ITEM FOR ZONING AND PLATTING COMMISSION

SUBJECT: 4709 Highland Terrace

REQUEST: Retroactive variance from LDC 25-8-641 -- Impacts to three Heritage Trees.

Exhibit #1

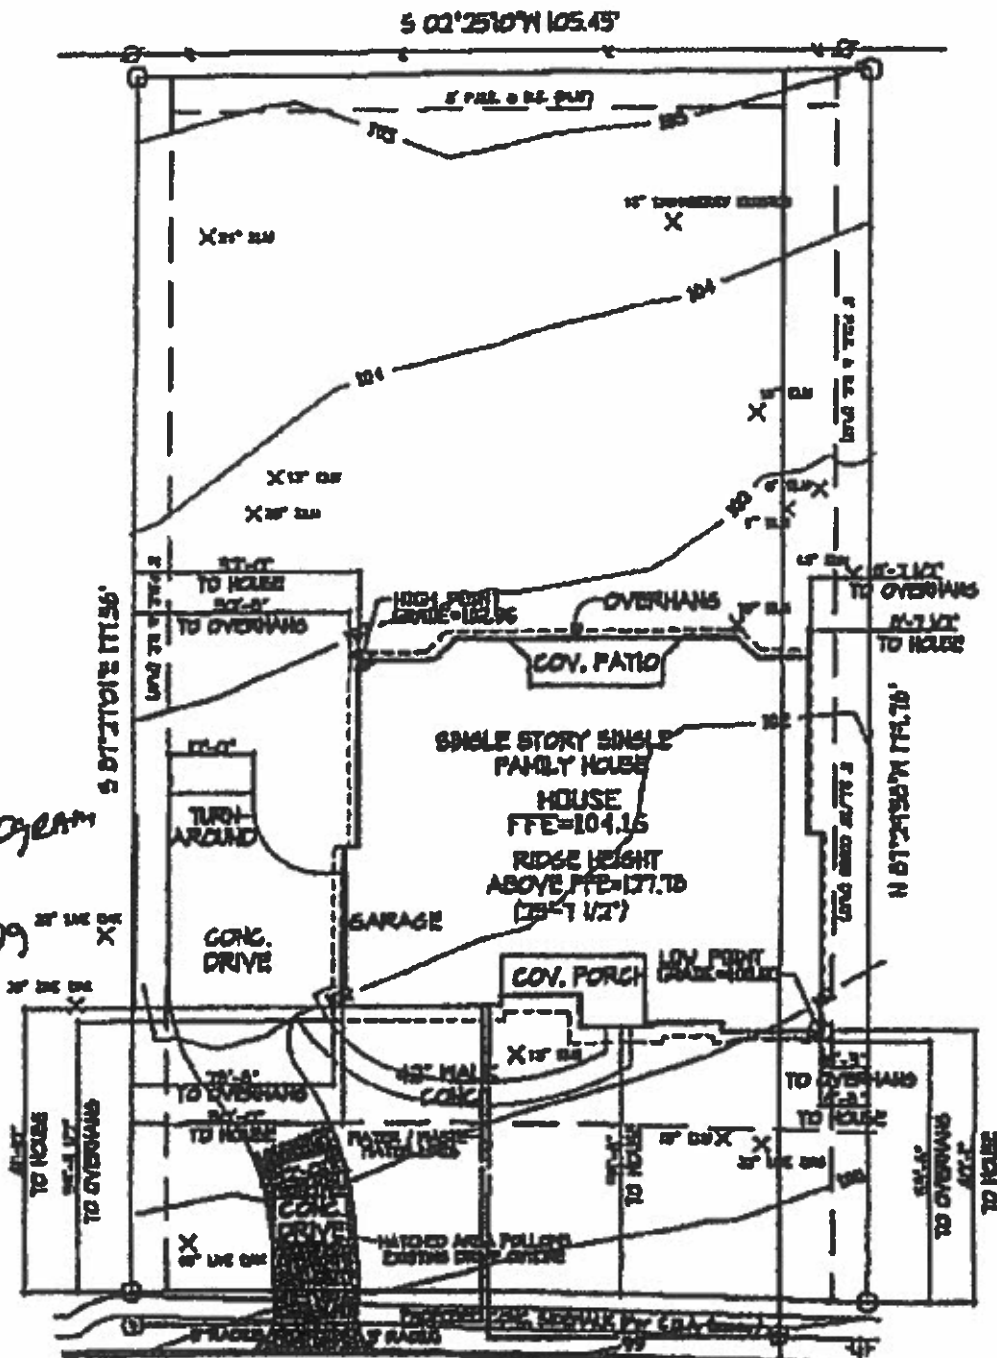
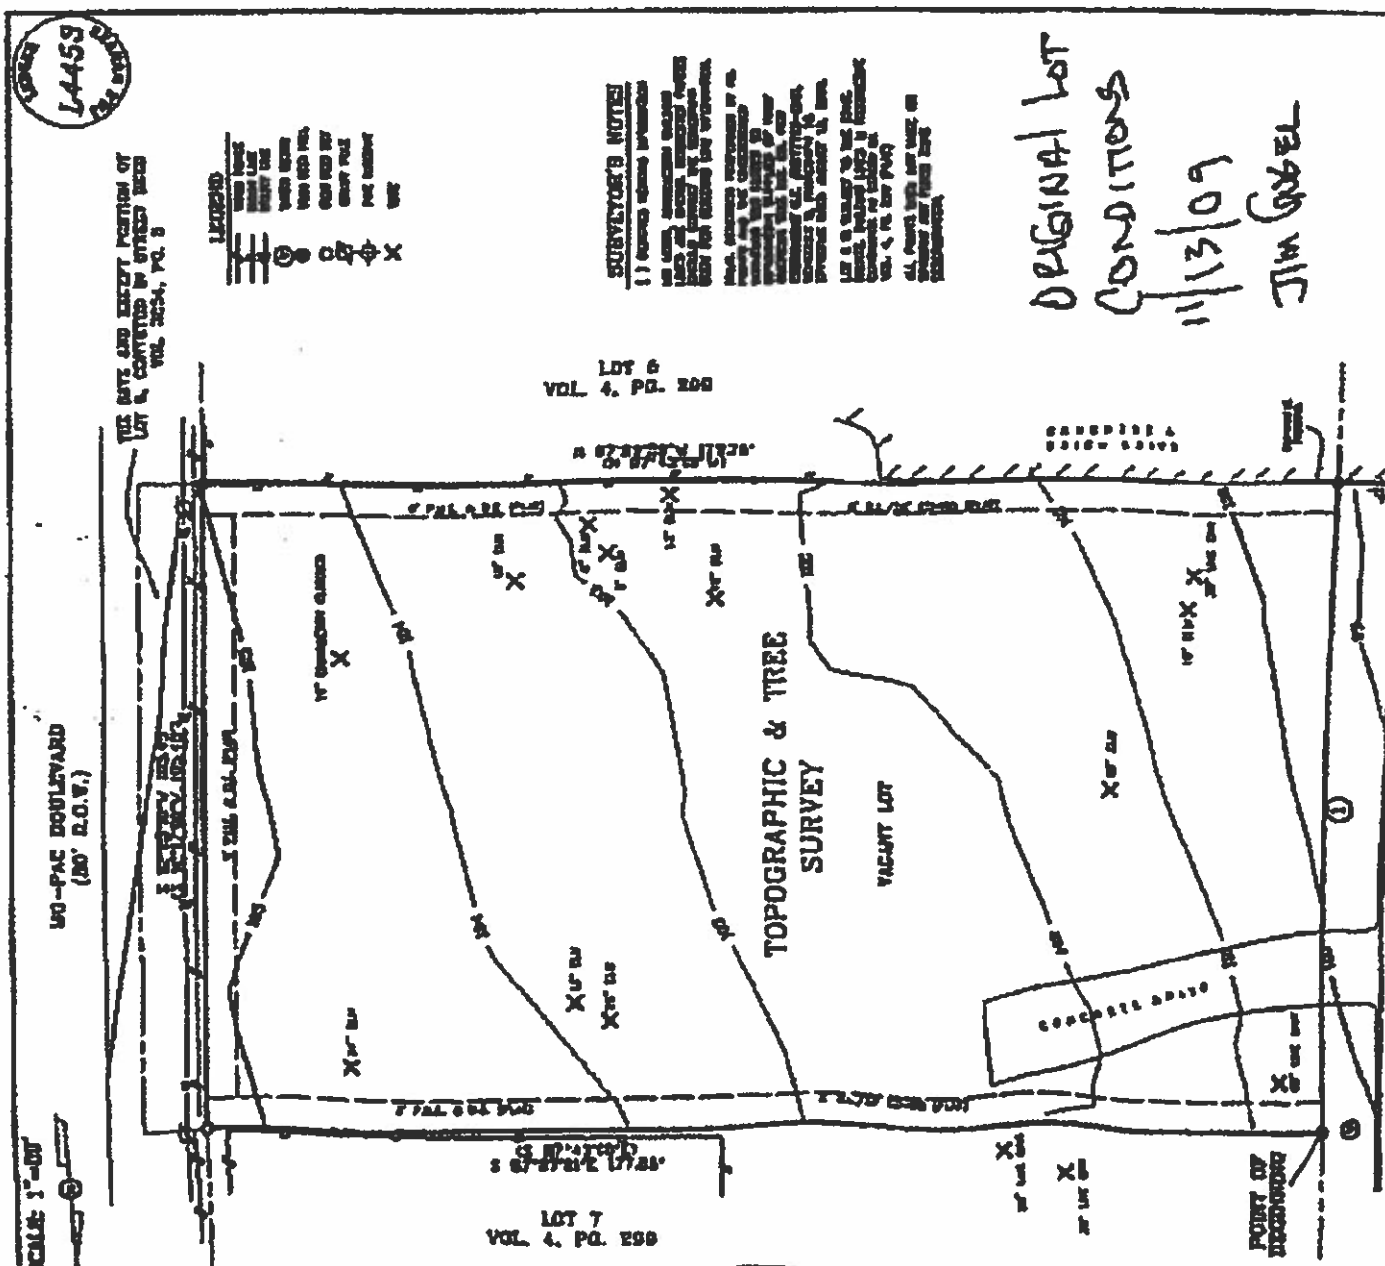
Comments: DRIVEWAY NEAR 36" x 28" on ADJ PROPERTY TO BE ESTABLISHED ABOVE
STREET. OLD DRIVEWAY DELETED. WATER & W/IN LINES TO BE ESTABLISHED CORNER
of lot. ADDITIONAL REQUIREMENTS BELOW

- ☒ Applicant agrees to plant 10 caliper inches, container grown, City of Austin Class 1 trees (i.e. Live Oak, Cedar Elm, Mountain Laurel) on the lot prior to obtaining a Certificate of Occupancy (minimum 2-inch trunk diameter).
- ☒ Prior to development, applicant agrees to supply an 8-inch root zone mulch layer and maintain tree protection fencing (chain-link, five-foot in height) throughout the project duration.
- ☒ Provide a receipt for remedial tree care and / or any required pruning as performed by a certified arborist.
- ☒ No impacts are permitted within the tree 1/2 critical root zone (see EOM 3/5-2). Including trenching for utilities.

Exhibit # 8

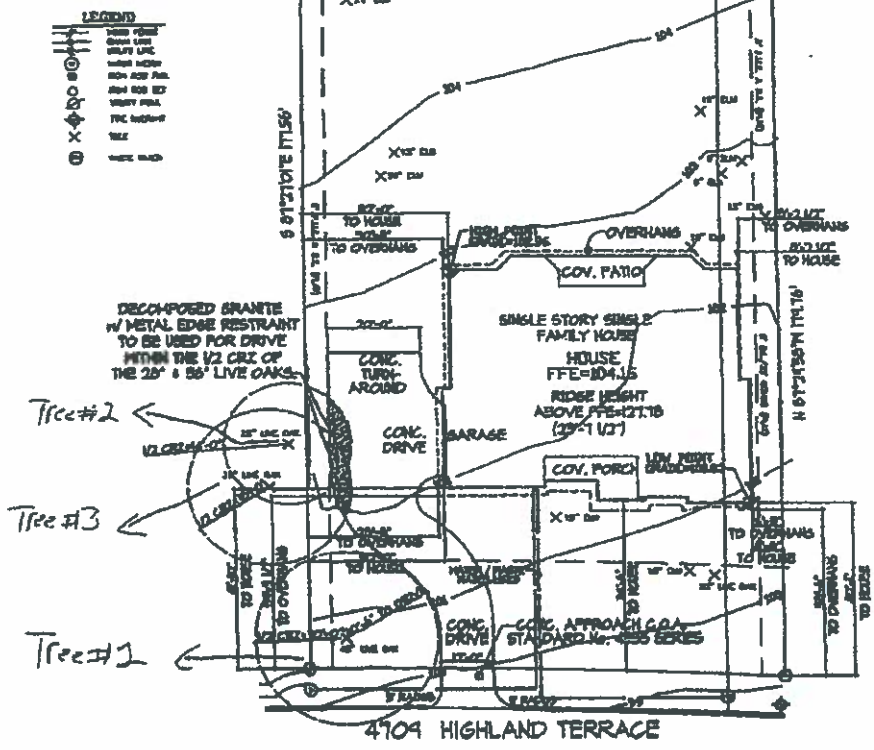
Since this time City Arborist staff informed the applicant that a retroactive variance must be requested and have worked with the applicant to bring the driveway location and sidewalk excavation into compliance. The driveway location has been shifted to avoid the ½ critical root zone (20' from cross-sectional center point of 40" Live Oak (Tree #1)) (Exhibit 8). The applicant is also proposing to use decomposed granite as the driveway material for the surface area that occurs within the ½ critical root zone of the neighboring 26" (Tree #2) and 36" (Tree #3) Live Oaks. Decomposed granite will assist with porosity over the root zone allowing for additional water uptake. The current proposal locates the driveway approximately 10' further away from the 40" Live Oak (Tree #1) than the driveway location permitted on November 13, 2009. The current proposed driveway encroaches no further into the critical root zones of the neighboring 26" (Tree #2) and 36" Live Oaks (Tree #3) than what was permitted in November 13, 2009, regarding reuse of the existing driveway footprint.

1/2 critical root zone of the 40" Live Oak as well. The plan is to move the driveway approach to the south approximately 9-10 ft. This way we keep the entire approach and driveway out of the 1/2 critical root zone of the Live Oak. Lastly, we propose using decomposed granite in the part of the driveway that encroaches the neighbor's (North side) 26" Heritage tree's 1/2 critical root zone. The granite will be supported with steel trim on the outside edge of the 1/2 critical root zone of the 26" Heritage tree.
